EIA REPORT

APPENDIX G:

Copies of Correspondence from
I&APs during the Scoping
and EIA Phases

**Scoping and Environmental Impact
Assessment** for the Proposed
Development of a 75 MW Solar
Photovoltaic Facility (KENHARDT PV 1)
on the remaining extent of Onder Rugzeer
Farm 168, north-east of Kenhardt,
Northern Cape Province

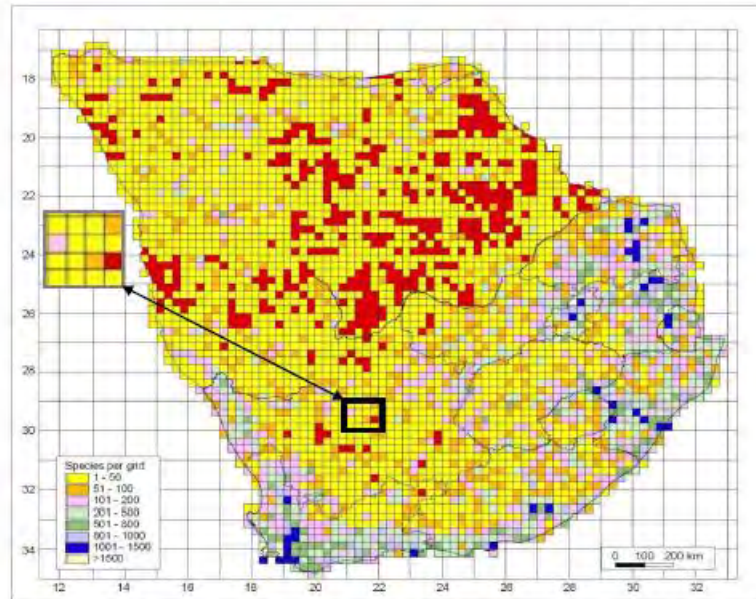
1. It should be noted that the areas where the proposed developments are to be constructed have been historically poorly surveyed, hence extrapolations from desktop studies for specialist's studies will give an incomplete representation of the biodiversity within the area (refer to Figure 2).

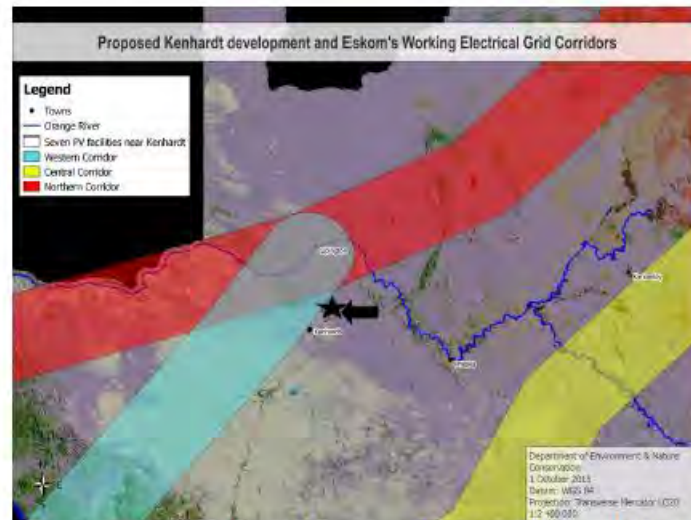
3. The proposed development do not form part of the Strategic Environmental Assessment (SEA) for Eskom's electricity grid upgrades and roll-outs as it falls outside one of the corridors identified by Eskom (i.e. the Western Corridor; one of the five identified corridors; refer to Figure 3). Comprehensive field surveys (within appropriate seasons) should thus be done for this specific area; it didn't form part of Eskom's assessment and the former project's surveys can thus not be used as baseline studies.

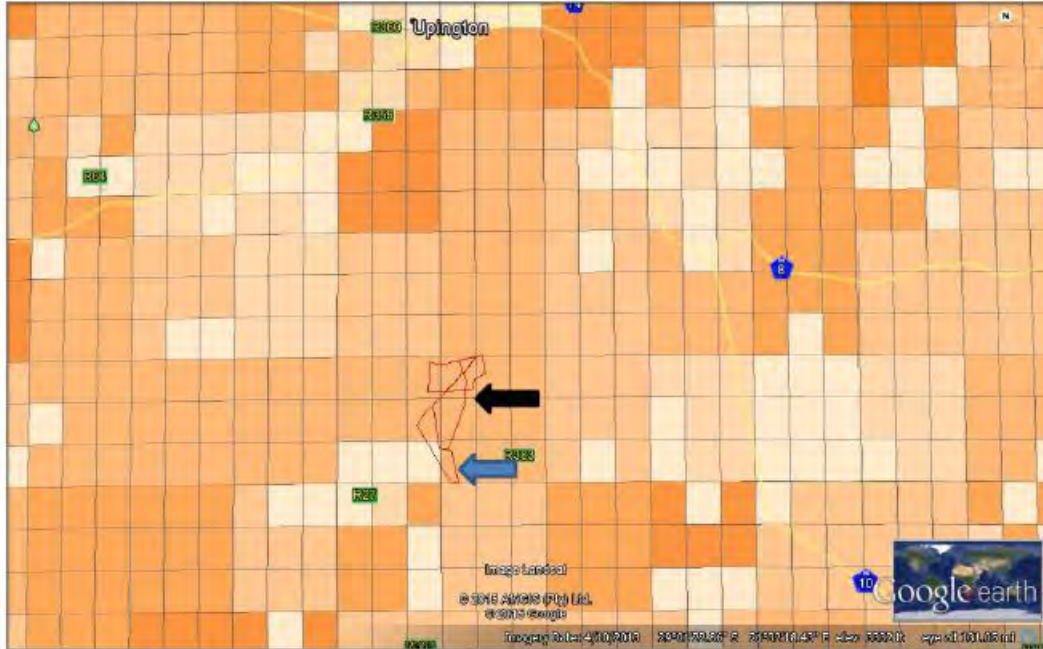
4. The proposed area does not fall within or close to an Important Bird Area (IBA), yet it does resort within a region of grids classified as being sensitive to Wind Farm facilities (refer to Figure 4). The darker the pendent the more sensitive the specific area is to Wind Farm facilities. Closer scrutiny regarding bird studies is thus a prerequisite due to possible impacts of birds on grid infrastructure as by implication local or regional migratory species that move around in response to surface water availability may be at risk from infrastructure collisions. It is also critical to point out that bird data for this area is based on the South African Bird Atlas Project 1 (SABAP1); data published in 1997 and recorded at a much broader scale than the SABAP2 data survey. Evidently, one can conclude that data for this area is outdated. This is specifically highlighted as a point of concern as each of the three PV projects will be separately linked to the Eskom grid through its own set of powerlines.

Figure 5. Several landscape scale connections through drainage lines are evident within the area in question. The two proposed facilities i.e. the Three Solar PV (blue arrow) and Seven Solar PV (black arrow) are to be located in close proximity of drainage lines and wetlands.

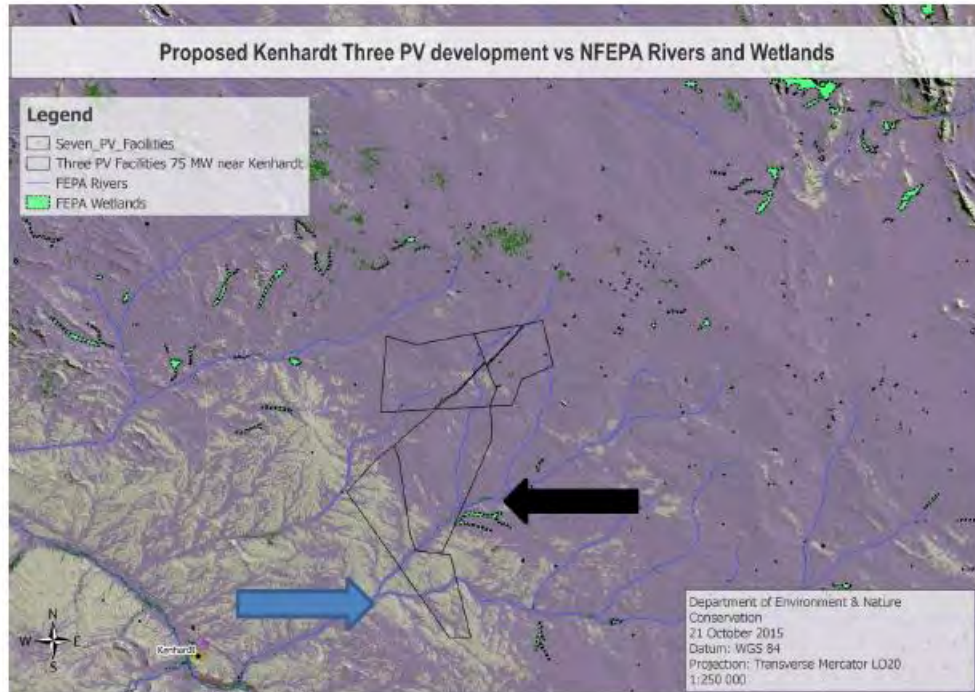
vegetation types is poorly conserved in formal protected areas and extensive areas have been historically overgrazed. As a result, large areas are currently degraded and drainage lines have been modified as a result of anthropogenic impacts. As a result of the extent of the area, impact would most likely be on landscape connectivity as the site is in close proximity of drainage lines and wetlands (refer to Figure 5).
